# UNITED STATES PATENT AND TRADEMARK OFFICE

# Office Action Summary

10/563,338

LAGLER, LOUIS

Fig. 1 of US Patent No. 5,148,912 (Nozawa hereinafter)

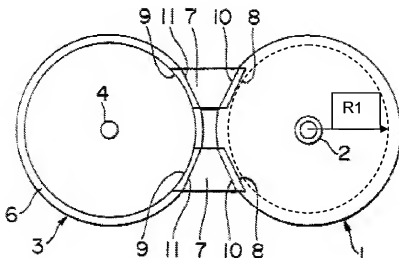
9. In re Claim 1, with reference to Fig. 1 and Fig. 4 above, Nozawa discloses: A closure moulded in closed position with

- a ring shaped body (see Fig. 2), the ring shaped body having an opening (see Fig. 2) extending in an axial direction and having substantially the same diameter at

- a lid (3), the lid having substantially the same diameter as the ring shaped body (see fig. 3) and positioned immediately adjacent to the opening at a top open end of the ring shaped body when the lid is in the closed position, the lid comprising a sealing means (4) to seal an orifice (2) of the bottle, whereby the body (see ring shaped body) and the lid (3) are separated to [from] each other by a circumferential gap (see Fig. 2).

- a snap hinge comprising a first and a second trapezoid element (7) and a first and second pair of film hinges (10, 11) each pair defining a first and a second plane (Fig. 4), the first and the second pair of film hinges (10, 11) connecting the first and the second trapezoid element (7) to the lid (3) and to the body (1), whereby the first and the second plane are arranged substantially parallel to an axis A (Fig. 4) of the closure.

Fig. 4 of Nozawa

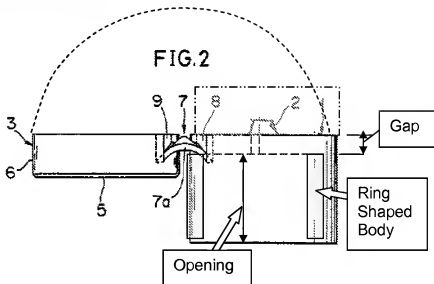
19. In re claim 4, with reference to the Figs. above, Nozawa in view of Smith et al. and Rentsch disclose the claimed invention including wherein the film hinges (10, 11) and the inner periphery of the closure are designed such that they do not protrude over a main inner radius (R1) of the closure (see fig. 1) (the largest inner radius would be from the center of the closure to groove 8, which stores the hinge and therefore would not protrude over the radius).

20. In re Claim 5, with reference to the Figs. above, Nozawa discloses that that the film hinges (10, 11) are defined by a plane on the inside of the closure and the outside of the film hinges (10, 11) is defined by two flat boundary planes, arranged at an angle each other, and a cylindrical boundary surface having a radius. It is implicit that the boundary planes of the film hinges be at angle to each and have a cylindrical boundary surface otherwise the closure would not open.

21. In re Claim 6, with reference to the Figs. above, Nozawa discloses that the trapezoid elements (7) are spaced apart by a cutout.

FIG.2

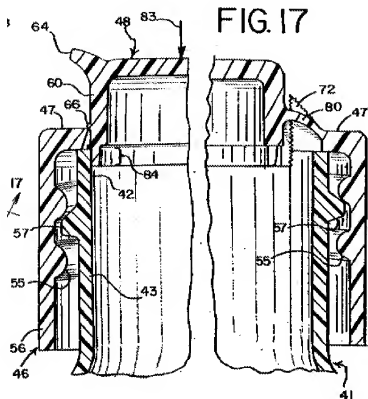
10. Note that the opening (2) could also be considered a "circumferential gap" because it is a gap having a circumference, and is between the lid and the body (ring shaped body).

Fig. 7 of Rentsch et al.

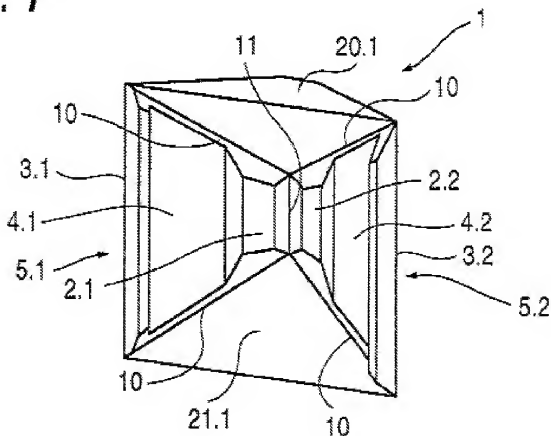
closure is capable of angles greater than 180°. Thus, the closure disclosed by Rentsch et al. can be in either range of angles when in the open position.

Fig. 3 of US Patent Application Publication No. 2002/0079282A1 (Harrold et al. hereinafter)

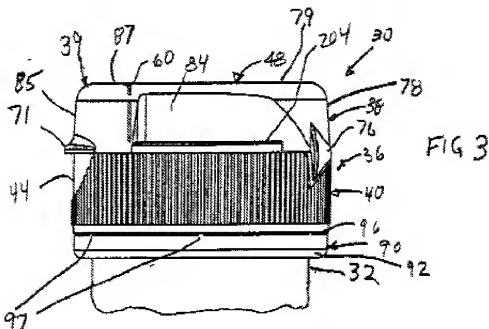
28. However, with reference to Fig. 3 above, Harrold et al. discloses tamper evidence means (90).

29. Thus, it would have been obvious to one having ordinary skill in the pertinent art at the time the invention was made to have modified the closure disclosed by Nozawa in

view of Rentsch et al. to have tamper evidence means as taught by Harrold et al. in order to achieve the predictable result of indicating if the closure had been tampered with.
